SAFETY EVALUATION BY THE OFFICE OF NUCLEAR REACTOR REGULATION

NEDE-32906P, "TRACG APPLICATION FOR ANTICIPATED OPERATIONAL
OCCURRENCES (AOO) TRANSIENT ANALYSES"

GE NUCLEAR ENERGY

PROJECT NO. 710

Figure 1 Comparison of Radial Power Distributions for two Methods used in the Analysis

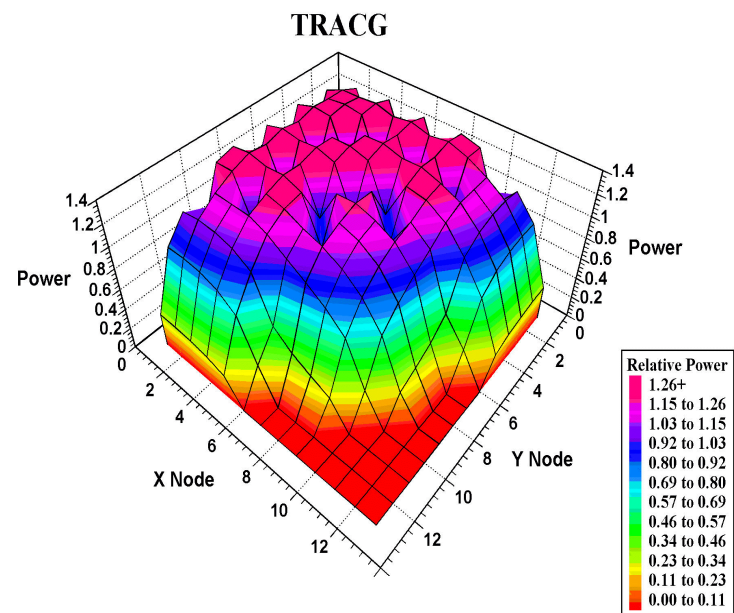
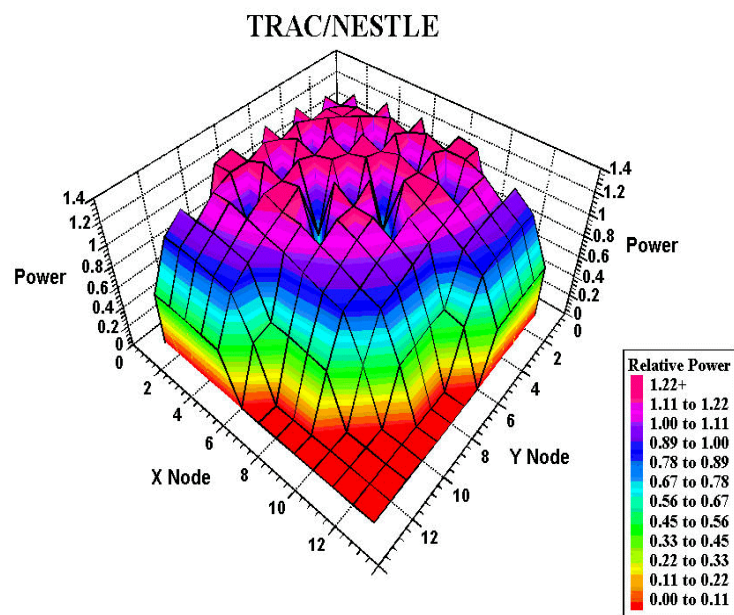
The staff and GNF predictions of the two fuel type core are compared in Figures 1 and 2. Figure 1 shows a three-dimensional view of the initial steady state power distribution and Figure 2 shows the infinite eigenvalue as a function of time for the two fuel types used in the core. One difference between the two predictions in Figure 1 is the fact that the staff results are not as smooth as the GNF analyses. This difference is typical when comparing modern nodal methods to finite difference methods, possibly because nodal methods attempt to more accurately account for inter-assembly gradients. Otherwise, Figure 1 demonstrates that the two methods quantitatively agree well with one another. Figure 2 shows that the void reactivity input into the two respective kinetics codes is equivalent.

Figure 5 Total Reactor Power for Simulated Pressurization Transient

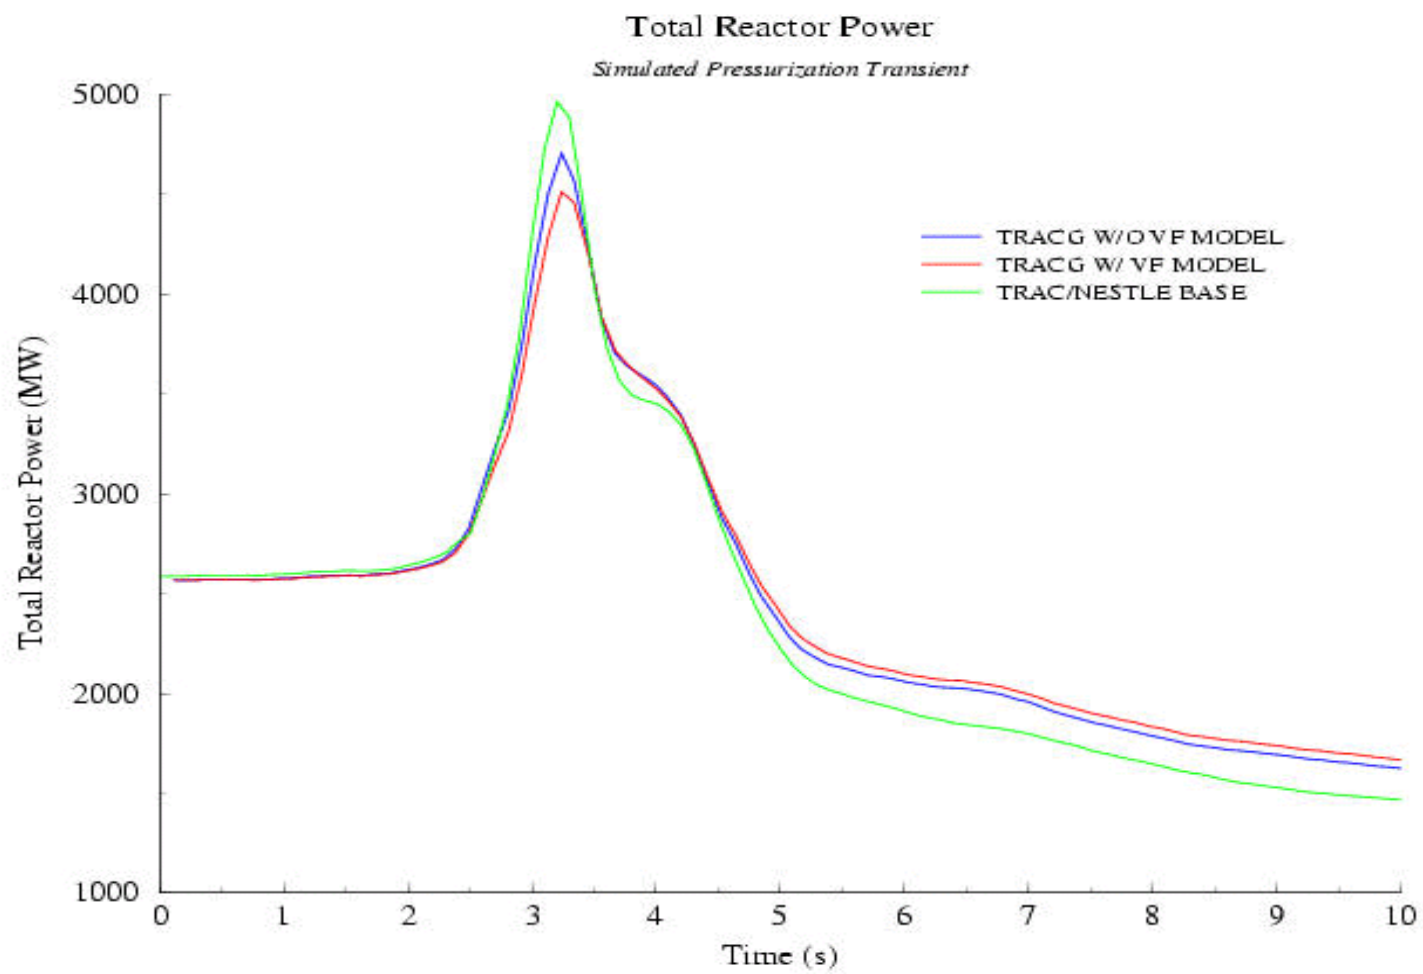
Returning to the discussion of Figure 5, the staff results and the TRACG results are in reasonable agreement. Although the TRACG results without the PIRT18 model agree better with the staff results, the results with the PIRT18 model are acceptable when one considers the following:

1. TRACG compares well with the Peach Bottom turbine trip tests. Although these tests were not as limiting as the transient considered in the test problem and the Peach Bottom core used older BWR fuel that was easier to analyze, the results do provide evidence that TRACG adequately simulates pressurization transients; and
2. The TRACG results, when compared to the staff's results, do not differ significantly enough to affect predictions of $\Delta\text{CPR}/\text{ICPR}$ values. This is true because as mentioned earlier critical power is a function of energy deposition, not power.

Figure 6 Comparison of Different Monte Carlo Evaluations of the Same GNF Lattice

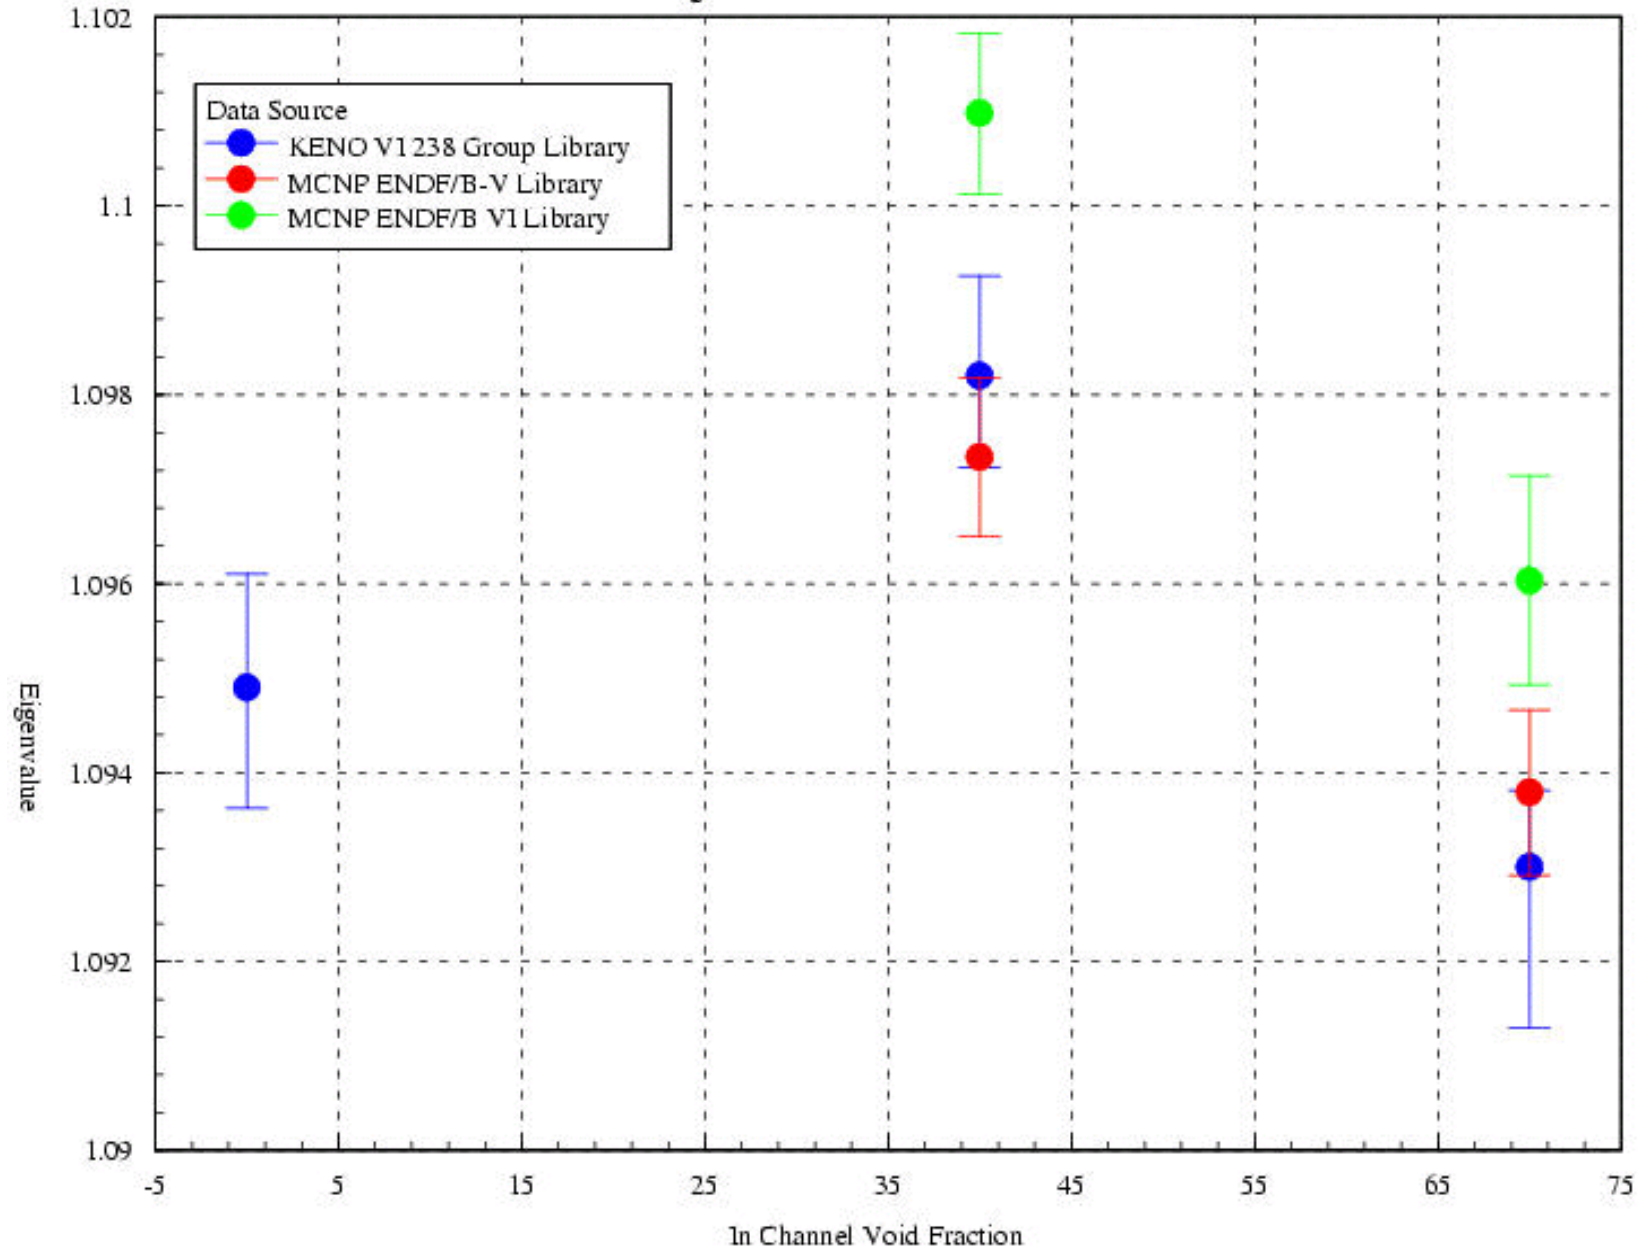
The staff independently assessed this model because the TRACG results are sensitive to it. The staff ran many MCNP calculations of a GNF fuel lattice using different modeling assumptions and different cross sections based on ENDF/B-V and ENDF/B-VI data. The results of the assessment identified a weakness in the GNF model. The GNF model uses the MCNP code, which is a Monte Carlo solver, to predict point values. Monte Carlo methods do not yield point answers; rather, they provide statistically significant ranges of answers. As the staff results in Figure 6 show, a wide range of different, but statistically equivalent answers, can be attained by using different cross section formulations and different (but equivalent) modeling assumptions. The differences presented in Figure 6 would not typically be of concern if it were not for the fact that BWRs are sensitive to void reactivity changes on the order of magnitude of the 95th percentile confidence intervals of the MCNP results.
